ENGINE - DIFFUSER CASE ASSEMBLY AND FITTINGS - REPLACE THE PRESSURE CAP AND FLARELESS
TUBE UNION (PART MATERIAL IS CHANGED) - CATEGORY CODE 8 - MOD.ENG-72-0276

V2500-ENG-72-0276

Location of the Pressure Cap (Typical For All Models Listed)
Fig.1

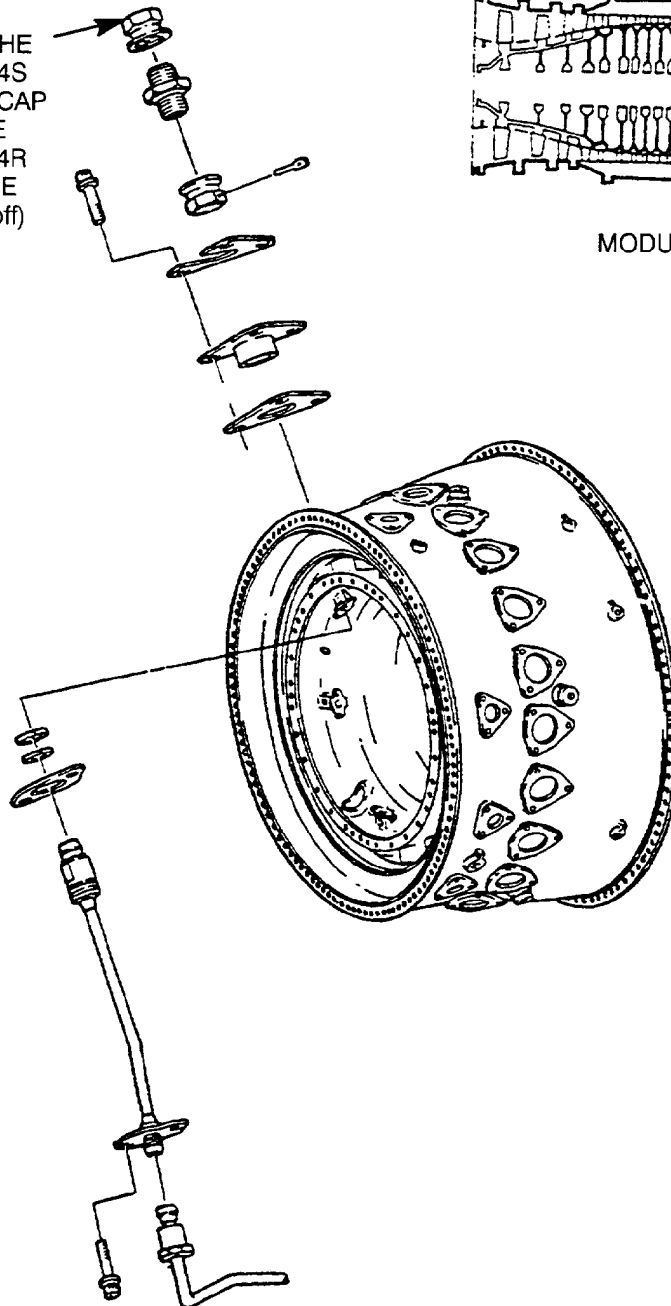
- A. Replace the MS21914-4S Pressure Cap (1 off) with the MS21914-4R Pressure Cap. See Figure 1.

REPLACE THE
MS21914-4S
PRESSURE CAP
WITH THE
MS21914-4R
PRESSURE
CAP (1 off)

Location of the Tube Union V2525-D5 and V2528-D5 Engines (79-34-02-01-109)
Fig.2

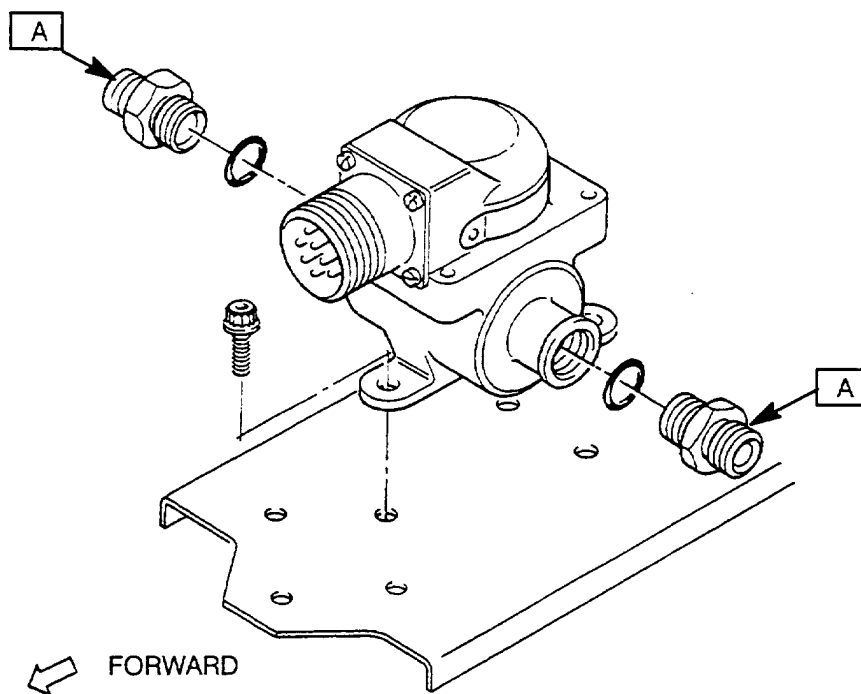
- B. Replace the MS21902-04S Tube Union (2 off) with the MS21902-4R Tube Union at two locations. See Figures 2 and 3.

REPLACE THE MS21902-04S UNION WITH
THE MS21902-4R UNION (2 off) ONE EACH
AT TWO LOCATIONS A

Location of the Union V2525-D5 and V2528-D5 Engines (79-35-16-01-109)
Fig.3

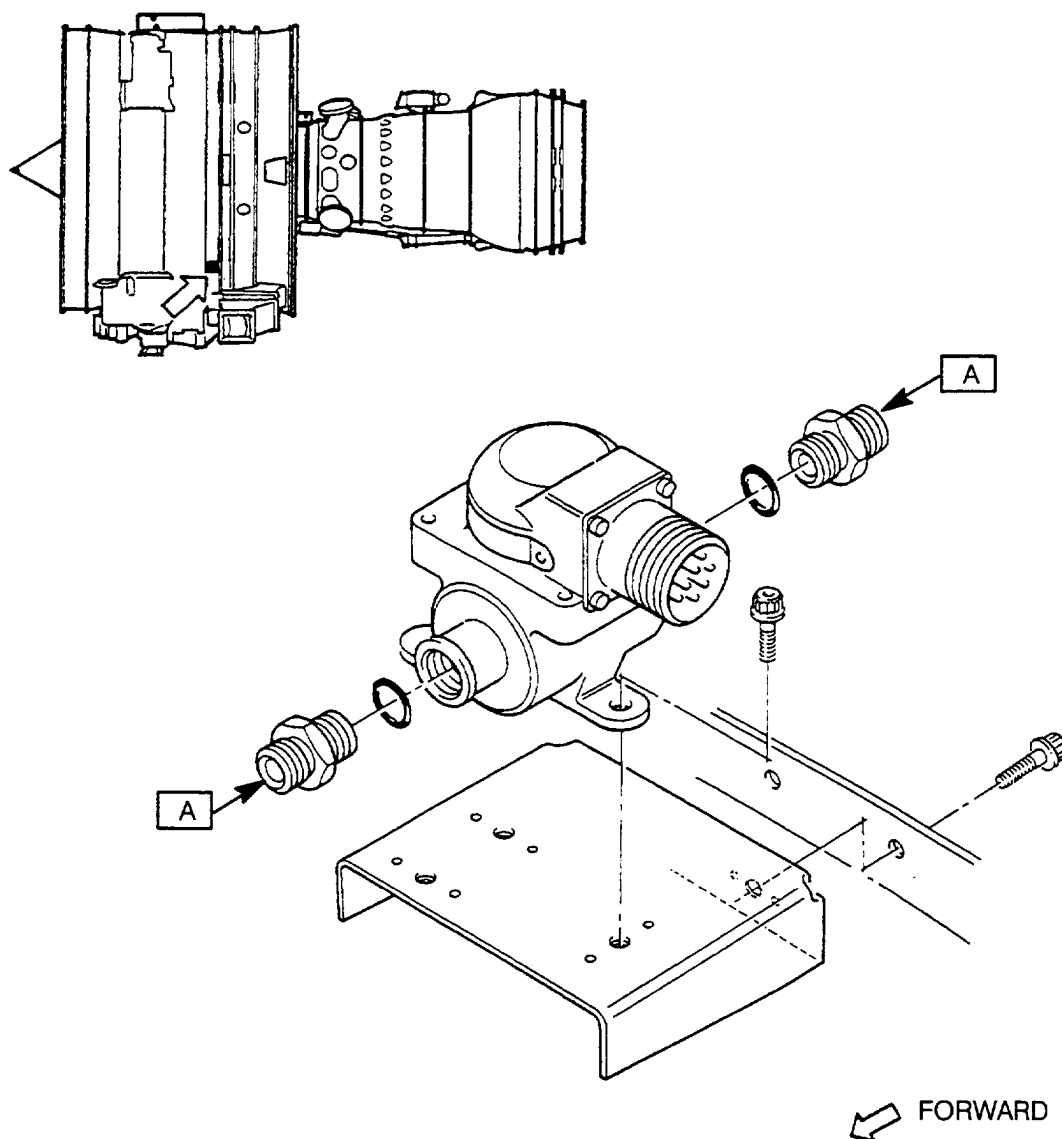
REPLACE THE MS21902-04S UNION WITH
THE MS21902-4R UNION (2 off) ONE EACH
AT TWO LOCATIONS **A**
